Product hierarchy no. *				Part no.	SBU	Type / Description	Customer part no.
SBU	PG	PGU	Type				
02	005	116	0000001132	See list below		KP01 (FH) Power Entry Modul	n.a.

Product Change Notification					PCN KP01 (FH)		
owner	creation date	release date	released by	change order no	rev	page	D10-013-552
huberth	2017-01-31	2017-02-06	buerglal	2012034	A	1 of 1

Old product appearance		New product appearance	
<p>Contact spring</p> 	<p>Connection (caulked terminals not soldered)</p> 	<p>Contact spring</p> 	<p>Connection (caulked terminals soldered)</p>

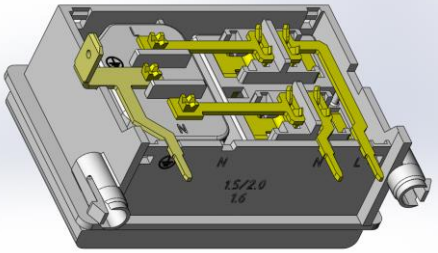
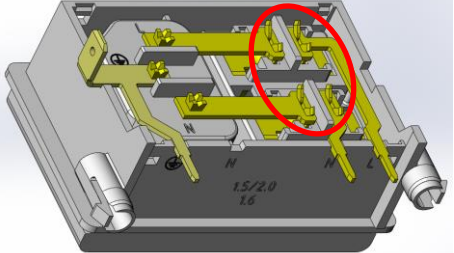
- Change of plastic material from PA6 to PBT (Socket and Fuseholder)
- Change of design of metal parts (Contact spring and Connection)

- Product improvement to fulfil the enhanced glow wire requirements according to the updated standard IEC 60127-6 and the standard IEC 60335-1 for appliances in unattended use.
- Recertification by VDE
- Recertification by UL
- Lower power dissipation due to additional soldering.
